Recommended text for the addition of microQSFP, QSFP-DD and OSFP MDIs to 802.3cd:

(Tom Palkert: 2017/03/07)

136C.3.x QSFP-DD/OSFP to 8×SFP28 cable assembly form factor

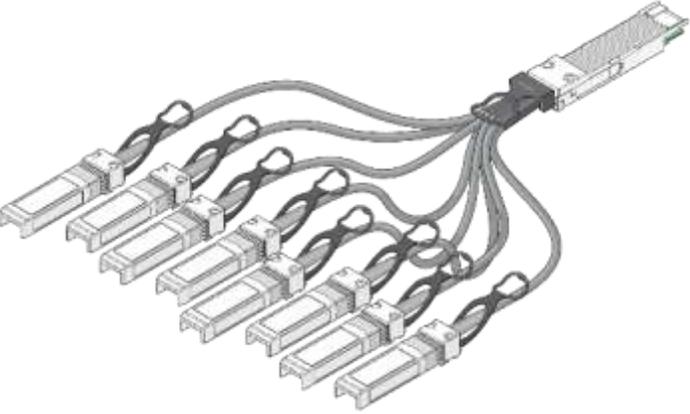
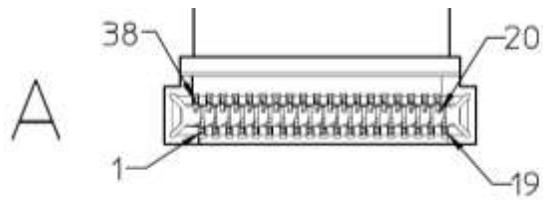
The QSFP-DD/OSFP to 8×SFP28 cable assembly has a QSFP-DD or OSFP plug as specified in

136.12.2/3 on one end, and eight SFP28 plugs as specified in 110.11.1 on the other end. It

may be used to connect a QSFP-DD/OSFP form factor host (see 136C.2.3) to up to eight SFP28 form factor hosts (see 136C.2.1) with one 50 Gb/s link to each SFP28 host. The cable assembly is illustrated in Figure 136C-x. The electrical characteristics of a cable assembly for this form factor are specified in 136.11, using the definitions in 136.11.7.2.2 and

See images below:

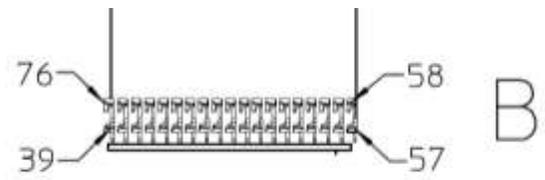
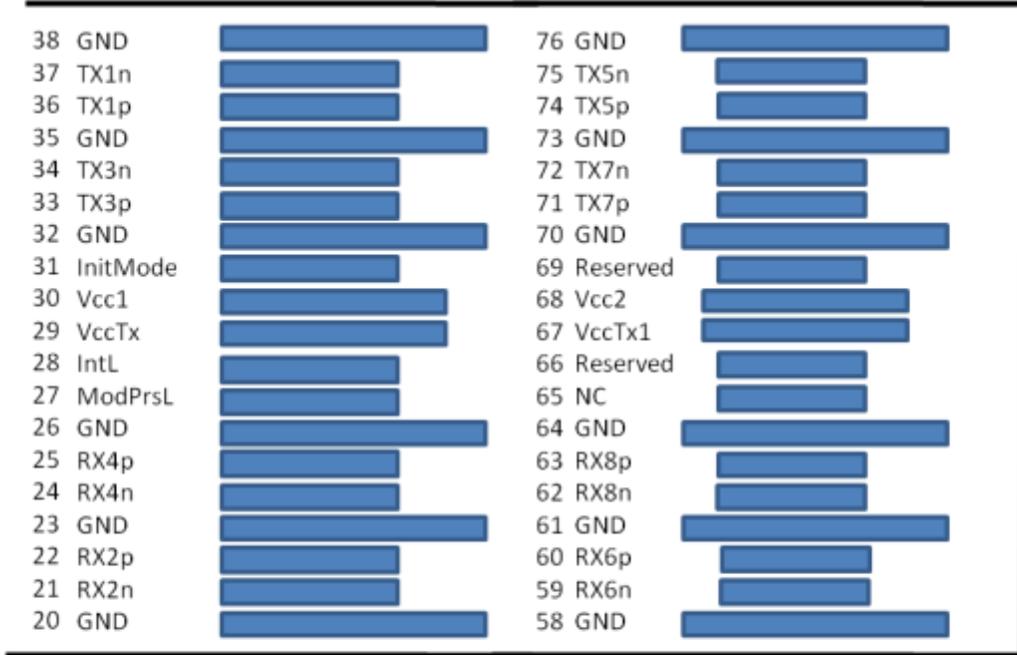
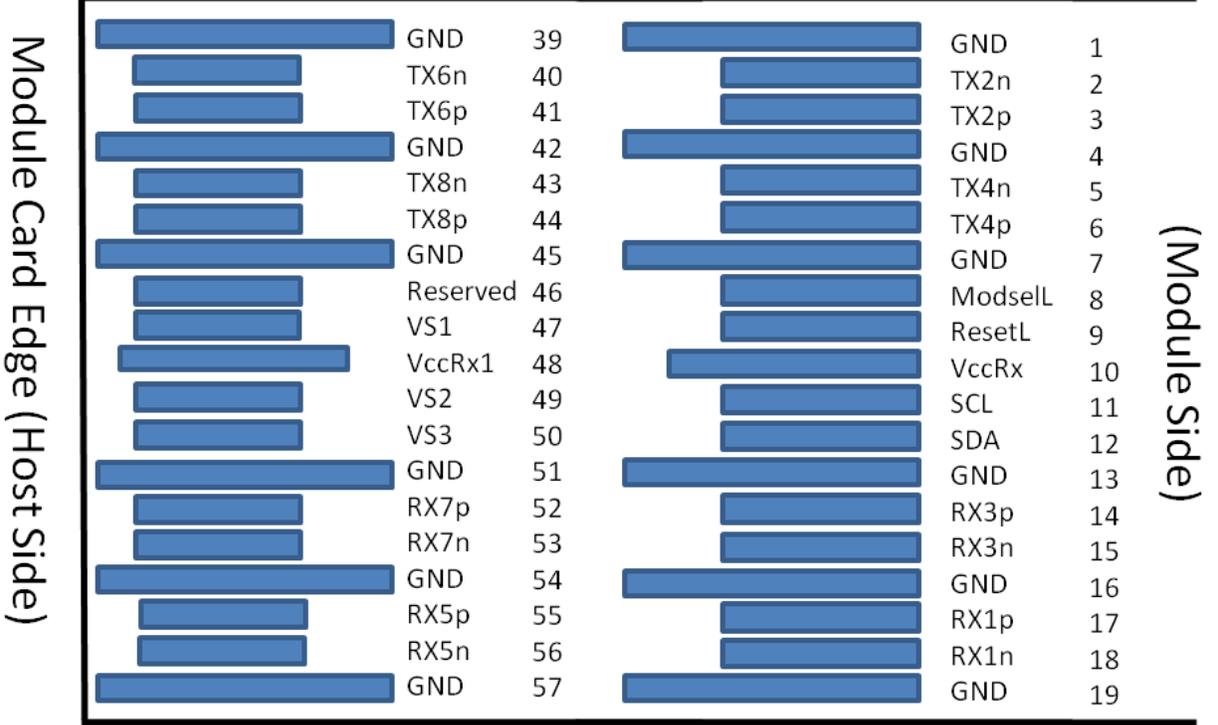
The Style-2 and style-3 MDI connectors of the 50GBASE-CR, the 100GBASE-CR2, and the 200GBASECR4 PMD comprises 76 signal connections for style 2 and xx signal connections for style 3. The Style-2 and style 3 50GBASE-CR, 100GBASE-CR2, and 200GBASE-CR4 MDI connector contact assignments shall be as defined in Table 136-

17. Note that the source lanes (SL), signals SLi<p>, and SLi<n> are the positive and negative sides of the transmitters differential signal pairs and the destination lanes (DL) signals, DLi<p>, and DLi<n> are the positive and negative sides of the receivers differential signal pairs for lane i (i = 0, 1, 2, 3, 4, 5, 6, 7).
